## 328. KMG Afterburner

Bulletin No.: FRB-SB006  
Ride: Afterburner by KMG International BV  
Relative Rides: All Models

Regarding: NDT testing of swing arm weld area

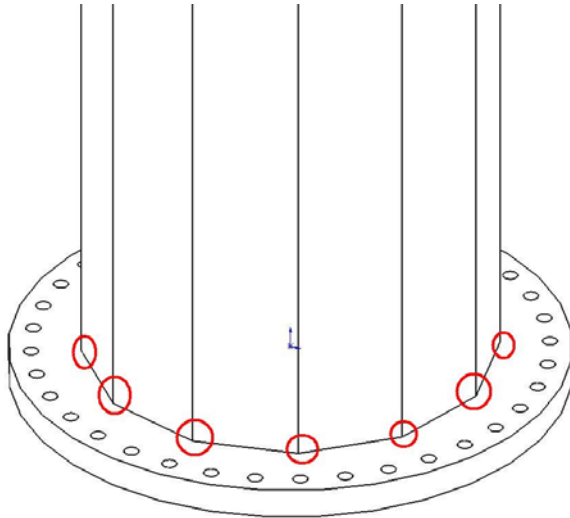
On recent investigation on one of the Afterburner rides, it was discovered that structural fatigue cracking of the swing arm was developing on Afterburner rides supplied by KMG. Applied area is the weld which connects the 12-sided tube to the bottom bearing flange.

Cracks were found in the area of the corners of the 12-sided tube, just above the weld to the bearing flange plate, perpendicular to the swing direction of the swing arm. Attached is a situation drawing of the affected area.

All Afterburner rides need to be tested for cracks by a certified NDT company by using visual and magnetic testing. For these tests, the paint must be removed from the steel tube and weld. The results need to be reported to KMG. In case cracks are discovered, the cracks need to be grinded out and to be repaired by a certified welding company.

**Reinforcements**

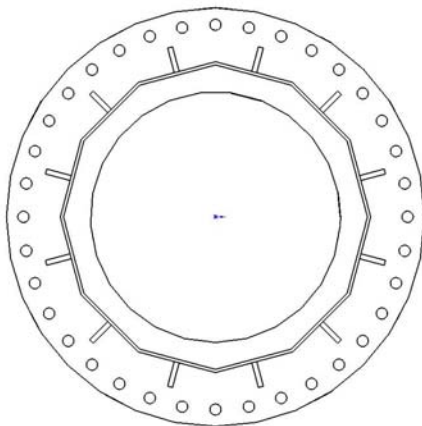
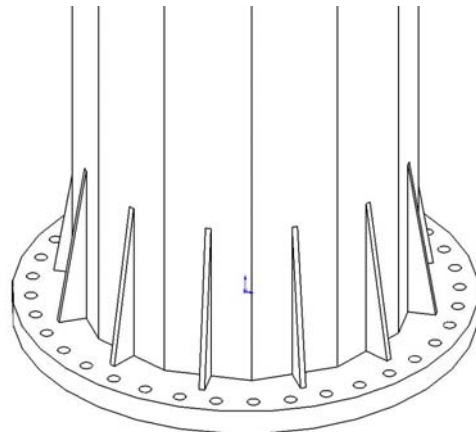
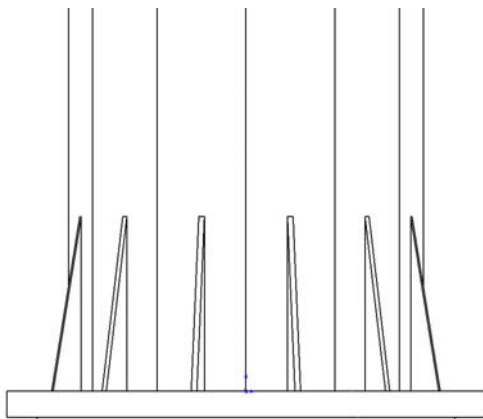
All rides need to have the affected area to be reinforced with gusset plates according to attached dimensions, material specifications and welding instructions.

Reinforcements are made by welding 12 gusset plates in a circular patten around the tube, on the center of each side of the tube's sides.

Dimensions of the gusset plates are 300mm long, 50mm wide and with a thickness of 10mm. Material is St.52-3 or S355.

In order to weld, the gondola bearing must be completely removed. After cleaning the weld area from paint and dirt the gusset plates should be fully welded. The ends of the welds should be smooth finished by grinding. The 50mm flange should be pre-heated to at least 150°C. Welding details are attached on the end of this document.
